# UNITED STATES PATENT AND TRADEMARK OFFICE

APPLICATION NO.	FILING DATE	FIRST NAMED INVENTOR	ATTORNEY DOCKET NO.	CONFIRMATION NO.
10/658,769	09/10/2003	Thomas J. Wood	IMED-0010-US	4079
40575	7590	12/17/2004	EXAMINER	
KCO LAW P.L.L.C. /DBA KEADY, OLDS & MAIER, PLLC 128 NORTH PITT STREET, 2ND FLOOR ALEXANDRIA, VA 22314			MITCHELL, TEENA KAY	
			ART UNIT	PAPER NUMBER
			3743

# Office Action Summary

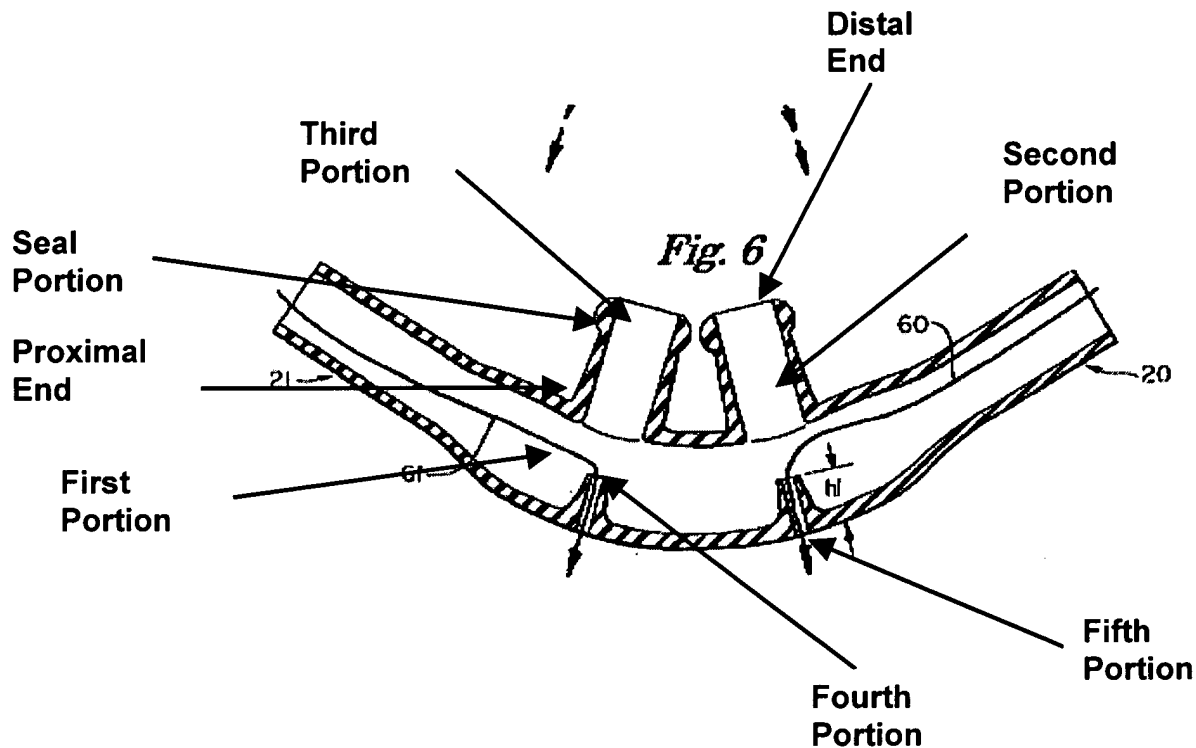
- a cannula (Figs. 3-7)
- with at least one nasal insert (12, 13) and at least one exhaust port (16, 17); the cannula forming a first portion of an input gas flow passage (see illustration of Fig. 4 below) to supply the ventilation gas to the user;
- the nasal insert being adapted to be inserted into a first naris of the nares of the user (Fig. 1),
- the nasal insert forming second and third portions of the input gas flow passage from the nasal cannula to a distal end of the nasal insert; and (see illustration of Fig. 6 below); and
- a seal portion (see illustration of Fig. 6 below) adapted to engage at least a portion of the nares, the seal portion being provided on the distal end of the at least one nasal insert;
- wherein the first, second, the third portions of the input gas flow passage are disposed at an obtuse angle to one another (Figs. 2-7).

With respect to claim 4, Strickland discloses wherein a proximal end of the nasal insert forms a second portion of the input gas flow passage having a substantially oval cross section (Figs. 2-7).

With respect to claim 5, Strickland discloses wherein a distal end of the nasal insert forms a third portion of the input gas flow passage having a substantially oval cross section (Figs. 2-7).
